Docket Number:	01-AFC-07C
Project Title:	01-AFC-7C Russell City Energy Company
TN #:	222836
Document Title:	Russell City Energy Center Petition for Modification Black Start Capabilities
Description:	N/A
Filer:	Eric Janssen
Organization:	Ellison Schneider Harris & Donlan LLP
Submitter Role:	Applicant Representative
Submission Date:	3/2/2018 4:12:39 PM
Docketed Date:	3/2/2018

Petition for Modification

Black Start Capabilities
Russell City Energy Center
Hayward, California

Figure 2: Northern Location A - North Location BESS General Arrangement

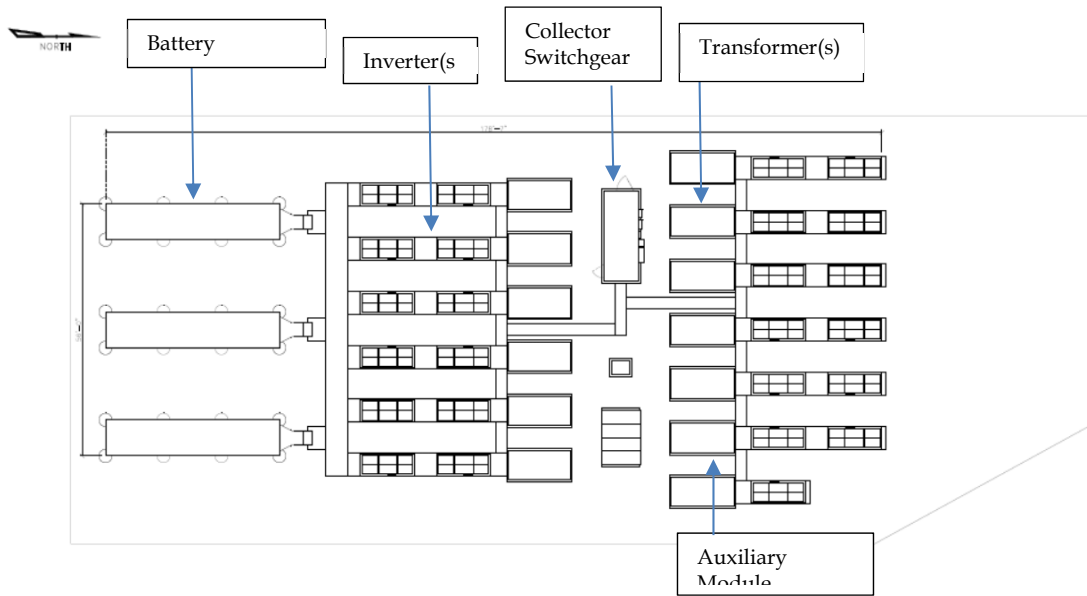
The Northern Location shown in Figure 2 has a footprint of approximately 15,000 square feet and includes a larger battery system than the Southern Location shown on Figure 3. However, both BESS configurations meet the black start system requirements. The BESS will include a combination of battery modules, inverters and transformers. If built at the Southern Location, which is approximately 10,000 square feet, the BESS will have fewer inverters with switched capacitor banks to support the high amount, but short time frame, of reactive power needed to start the large motors associated with startup cycle during a Black Start event.

Figure 3: Southern Location B - South Location

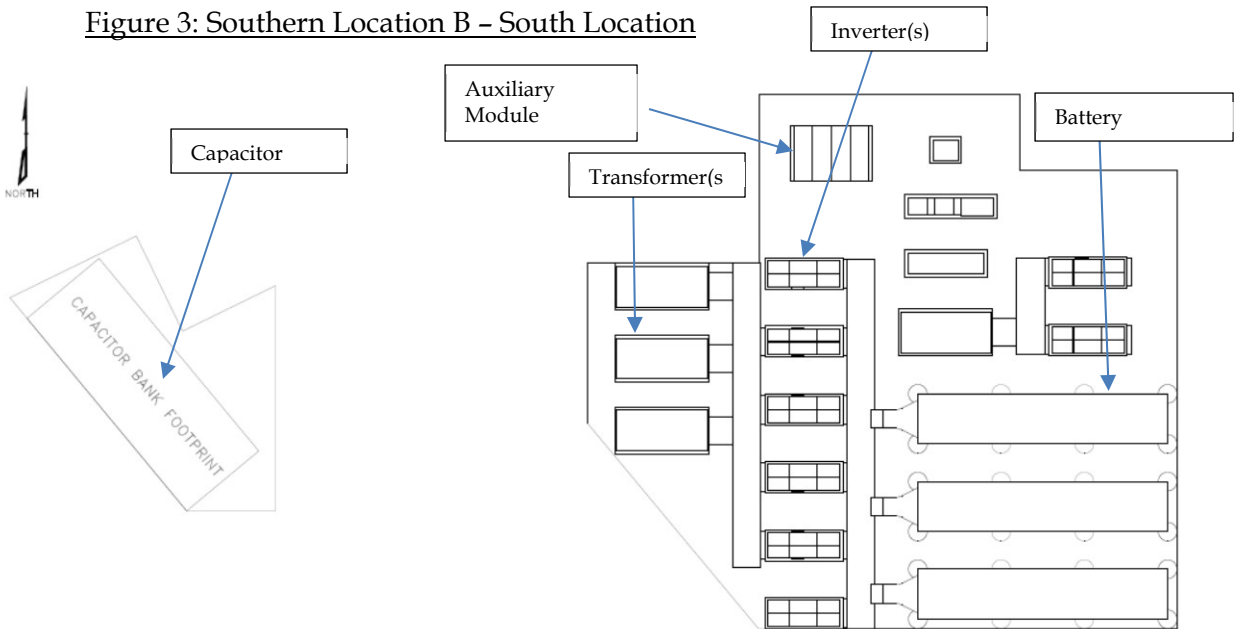
Either System would be tied into the power plants Motor Control Centers (MCC
